UNITED STATES PATENT AND TRADEMARK OFFICE

10/567,337

Office Action Summary	Application No.	Applicant(s)	
	10/567,337	HEYAN ET AL.	
	Examiner	Art Unit	
	Paul E. Patton	2822

DETAILED ACTION

FIG. 1

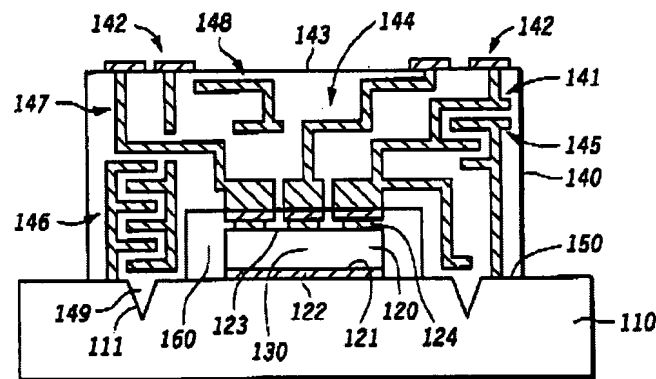
4. As to claims 1 and 7, Viswanathan discloses and shows (Fig 1 & 2) a multichip module having a main circuit board (220), at least one carrier substrate (140) mounted on the main circuit board and which is in electrical contact with the main circuit board, at least one semiconductor chip (130) on the carrier substrate (100) which is in electrical contact with the carrier substrate (110), wherein the carrier substrate has at least one cavity (160) on a mounting surface to accommodate said at least one semiconductor chip, connecting contacts for associated bumps (124) of said at least one semiconductor chip are provided in said at least one cavity (160), the at least one semiconductor chip being mounted on the connecting contact by using the associated bumps in a flip-chip technique, and the mounting surface (143) of the carrier substrate (140) being applied to a contact surface of the main circuit board (220) and the

mounting surface of the carrier substrate wherein the carrier substrate has many layers with conductor tracks (147) extending transversely through a plurality of layers, and a filling material (122) makes contact with a rear of said at least one semiconductor chip (130) in said at least one cavity without enclosing the connecting contacts and bumps including the steps of letting the at least one semiconductor chip into cavities provided for semiconductor chips on a mounting surface of the carrier substrate, mounting the at least one semiconductor chip by making contact with the bumps of the at least one semiconductor chip to connecting contacts in the cavities using a flip-chip technique; applying a layer of filling material to the contact surface of the main circuit board; and applying the carrier substrate having the mounting surface (143) to the contact surface of the main circuit board (220). (Paragraphs [0019] – [0025]).

5. As to claims 3 and 9, Viswanathan discloses and shows (Fig 1) that the application of the filling material (122) does not fill the interspaces of the at least one cavity completely.
6. As to claims 4 and 10, Viswanathan discloses and shows (Fig 1 & 2) the conductor tracks (147) of the carrier substrate (140) are led to the mounting surface (143) and are connected electrically and mechanically to conductor tracks of the main circuit board (220) for the simultaneous carrying of signals, dissipation of heat, encapsulation and shielding. (Paragraphs [0021] – [0024]).
7. As to claims 6 and 14, Viswanathan discloses that the carrier substrate is a multilayer, low-temperature co-fired ceramic (LTCC). (Paragraph [0026]).

14. As to claims 13 and 16, Viswanathan discloses and shows (Fig 1) that the application of the filling material (122) does not fill the interspaces of the at least one cavity completely.
